## **Application 2220163-RMACOM - Response to Request for Further Information dated 18 October 2022**

- 1.3 On 18 October 2022, Far North District Council (**Council**) made a request for further information in relation the Application (**Request**).
- 1.4 We have summarised each item in the request in italics, and provide a response to each item in the Request below.

TITLE  
**SCHEME PLAN**  
 BEING A SUBDIVISION OF  
 PT LOT 1 DP 67692 & LOT 6 DP 417562  
 STAGES 3 & 4

**IMPORTANT NOTE: PRODUCER STATEMENTS**  
 PS4 WILL NOT BE ISSUED AT COMPLETION OF WORKS UNLESS ALL REQUIRED TESTS AND INSPECTIONS HAVE BEEN NOTIFIED TO COOK COSTELLO AND COMPLETED DURING CONSTRUCTION

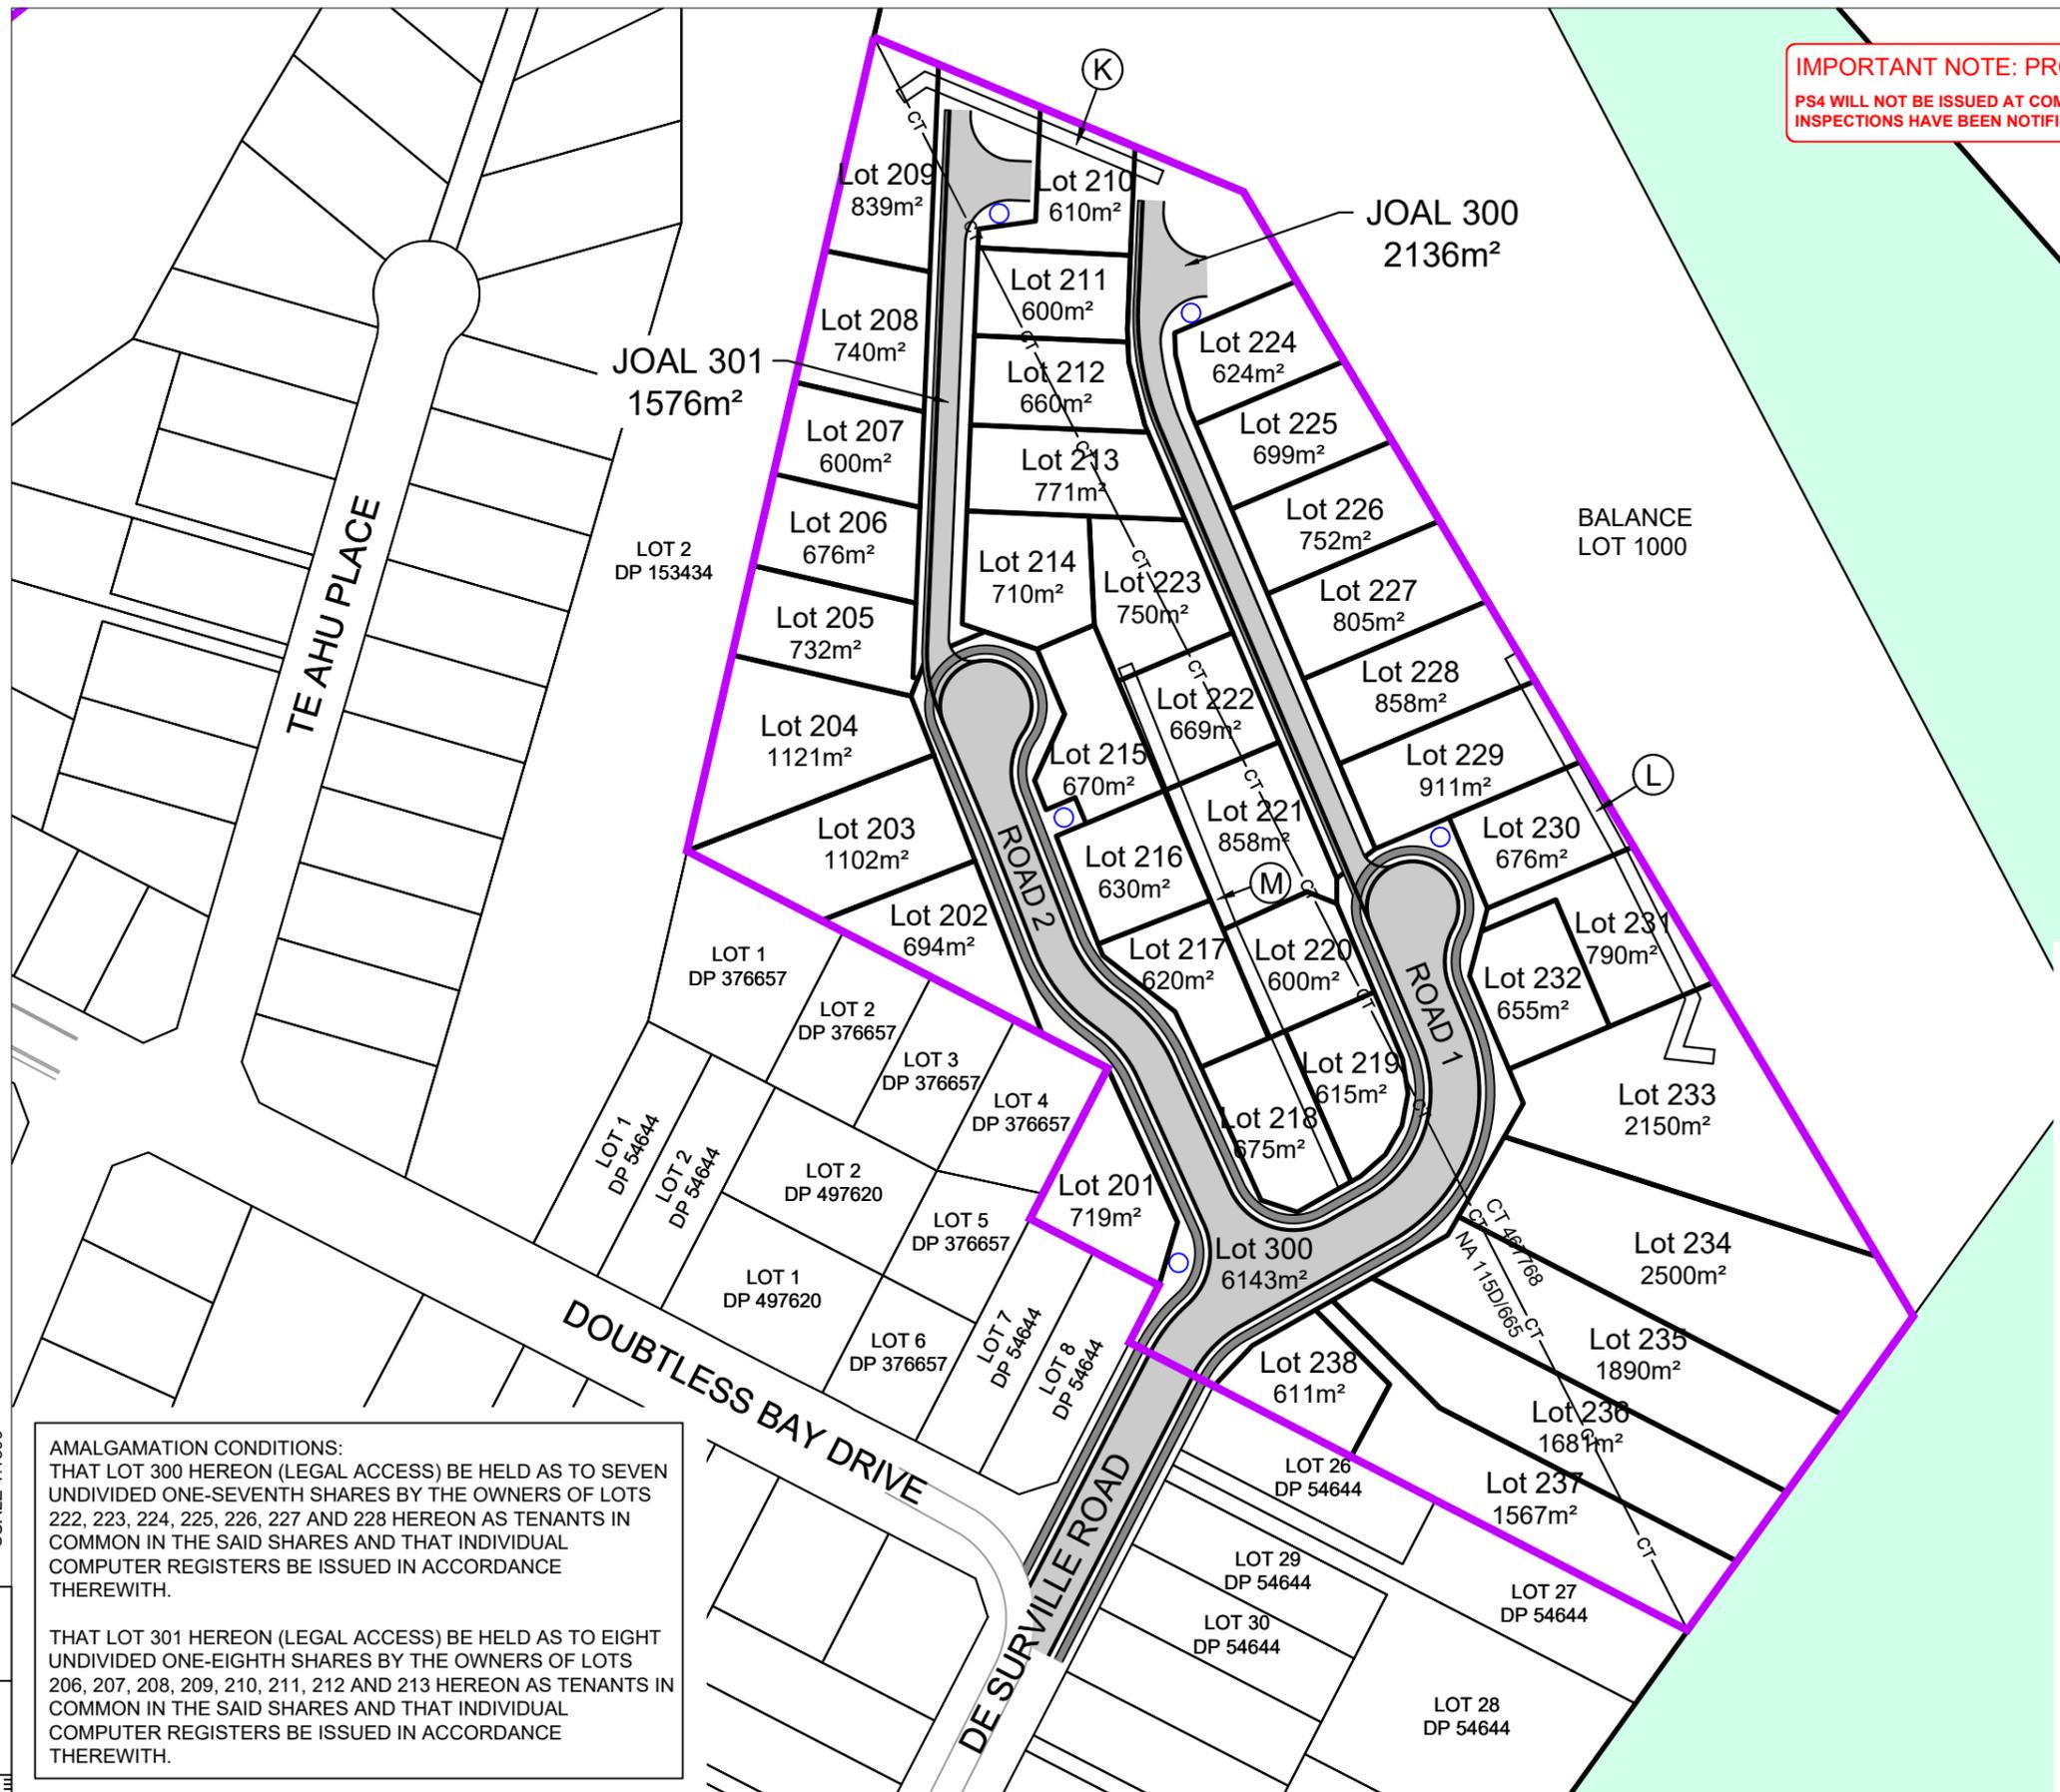
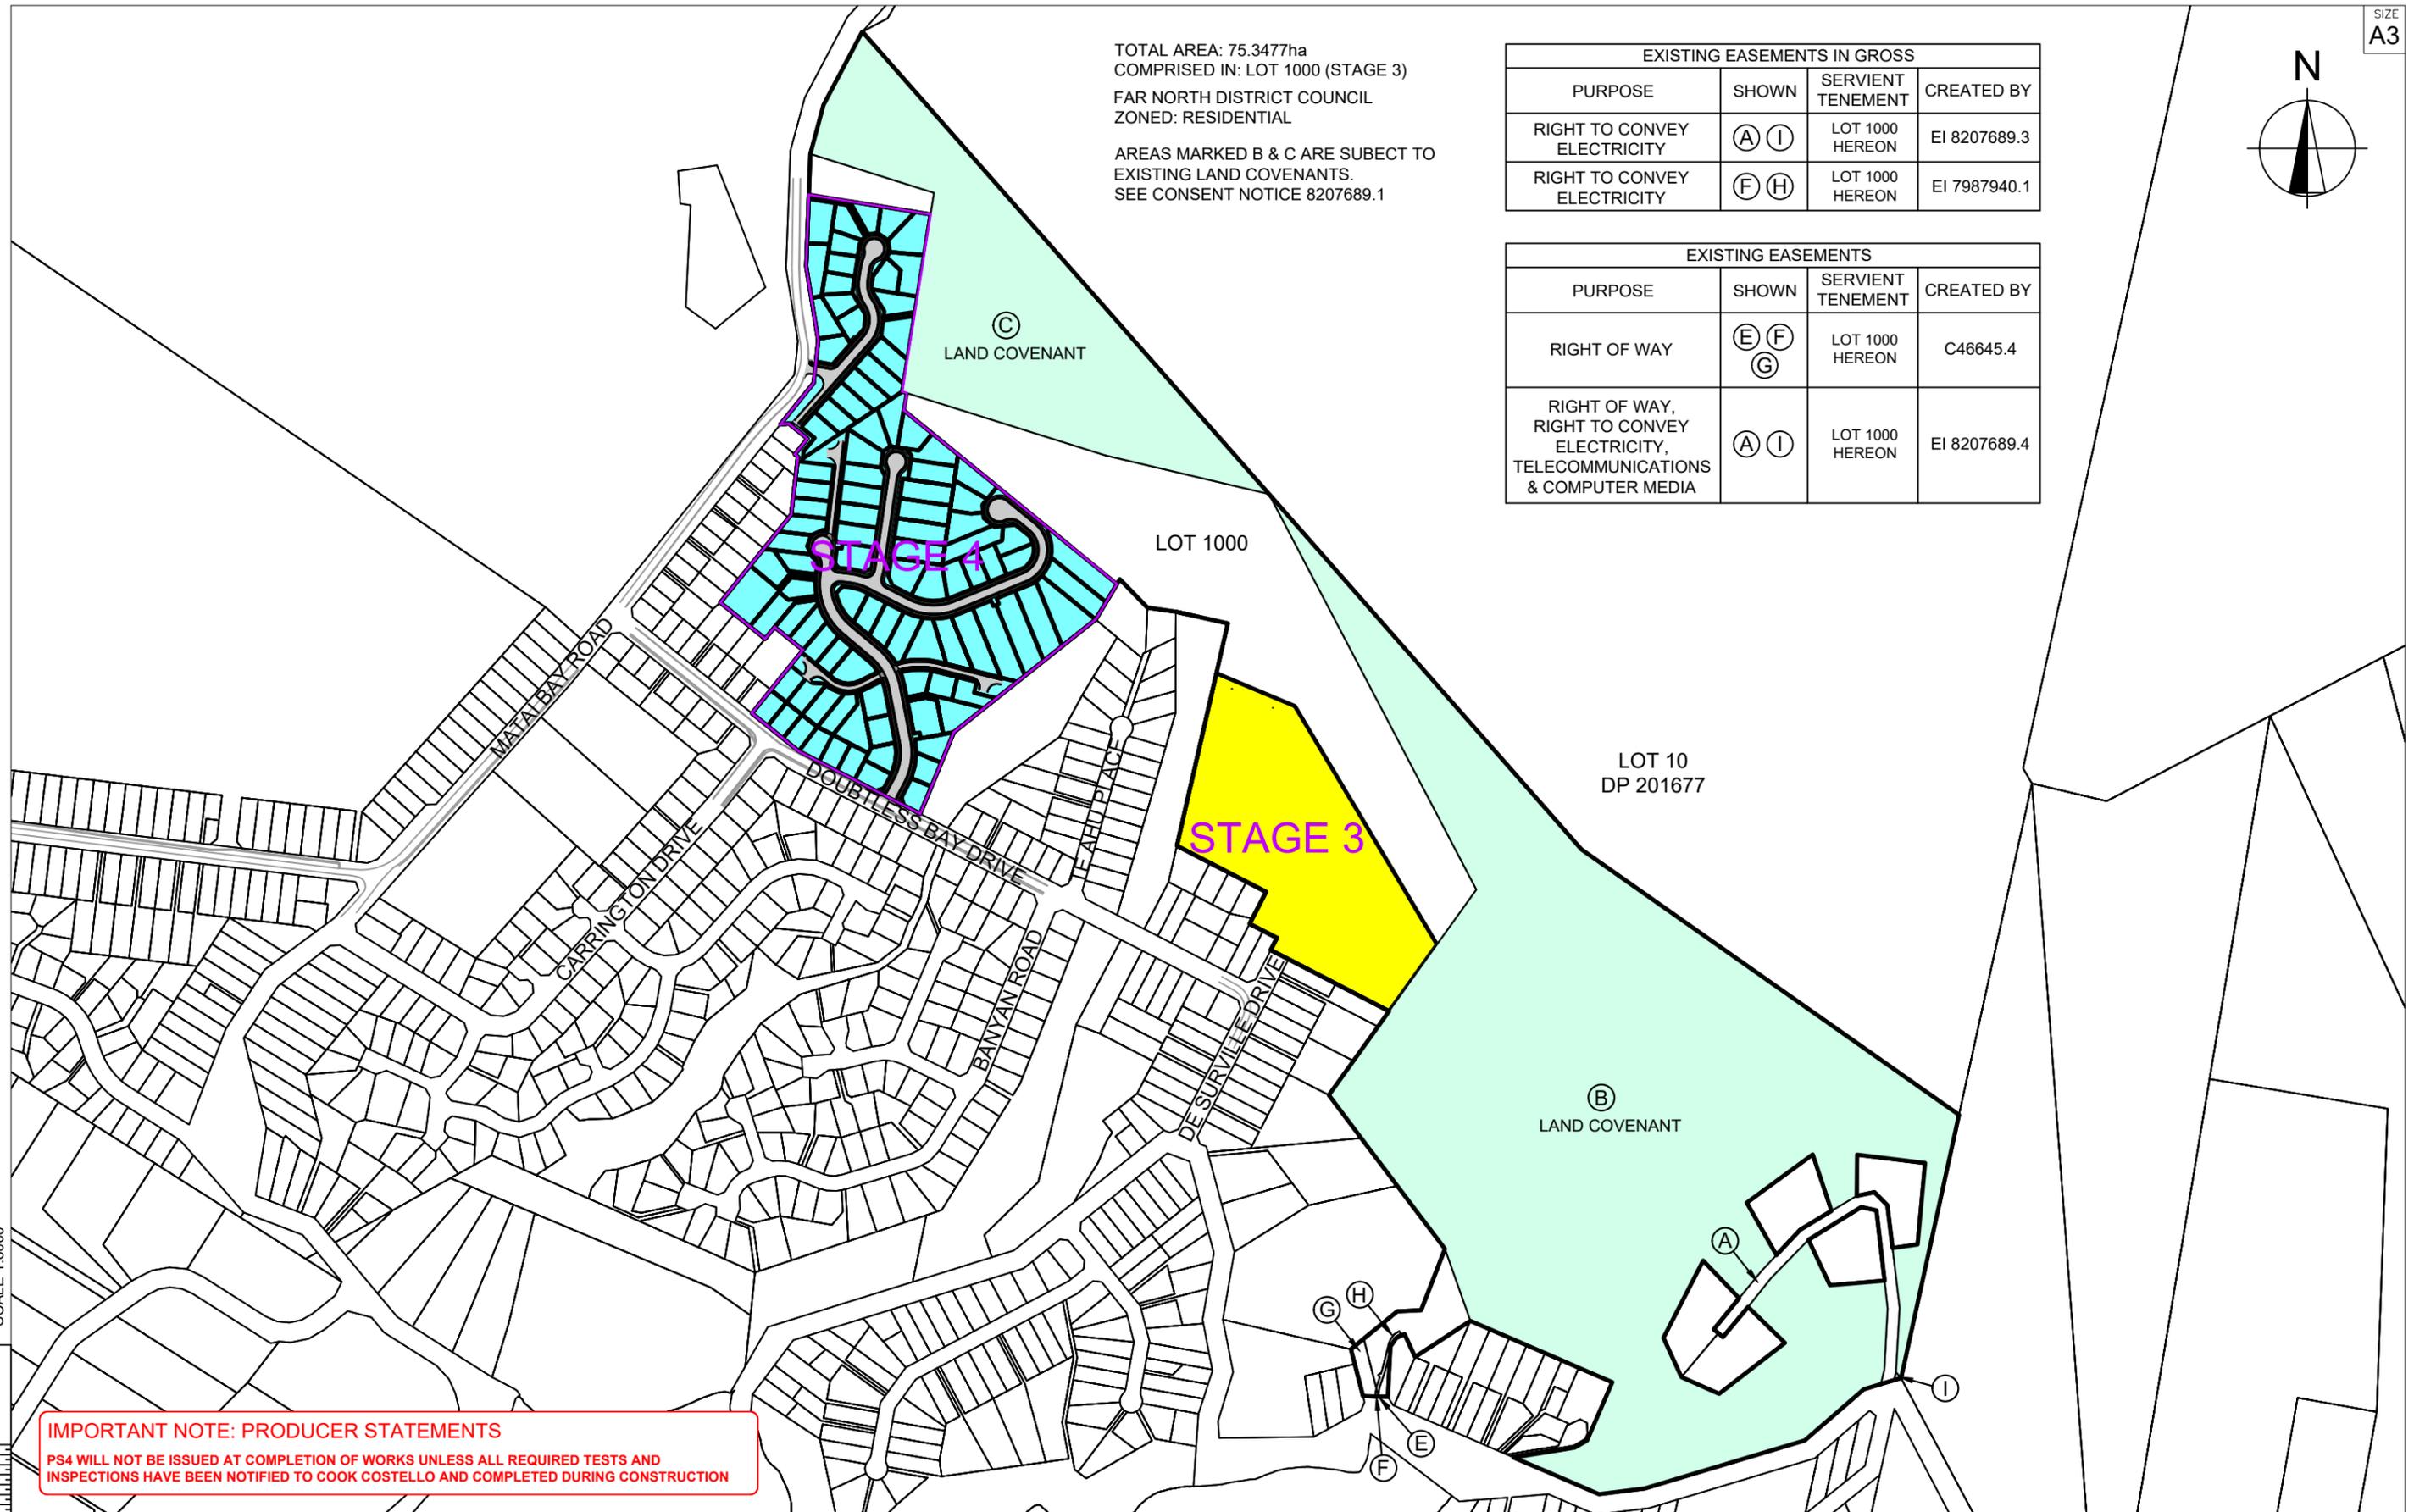
- 6.1 *Documentation supplied (Draft 2021 Scheme Plan Von Sturmers) for stages 3 & 4 show that Lot sizes are less than the required 600m<sup>2</sup> minimum size for Residential zoned sewerred sites (at a glance Lots 57, 96, 97, 99, 100 etc). The subdivision does not appear to meet zone standards as a controlled activity (13.7.2.1(v)).*

- 6.2 *Please confirm whether management plan subdivision is intended, and if so supply the management plan. Please supply all information necessary to complete the required assessment under section 13.10 of the Operative FNDP.*

- 6.3 Attached as **Appendix B** are revised scheme plans which identify that all lot sizes are 600m<sup>2</sup> or greater and therefore comply with standards of a controlled activity.

- 6.4 As a result of the revisions to the scheme plans, there have been amendments to the boundaries of the allotments. The outcome is that there is a minor decrease in the total number of lots. The revised plans provide for 38 lots in stage 3 and 100 lots in stage 4, which is two less lots than the scheme plans filed with the Application, which provided for 36 lots in stage 3 and 104 lots in stage 4.

- 6.5 We note the revised scheme plans show where some roads have been narrowed and are now proposed to be jointly owned access lots to minimise earthworks and improve the development layout.

- 16.4 *What is considered the optimum size for lots in stage 4?*
- 16.5 The revised scheme plan attached to this letter shows the appropriate size for lots in stage 4 of the proposed subdivision. The proposed lots all have an area greater than 600m<sup>2</sup>, and allow for a 14m x 14m square with a 3m setback from the road boundary and 1.5m side yards.
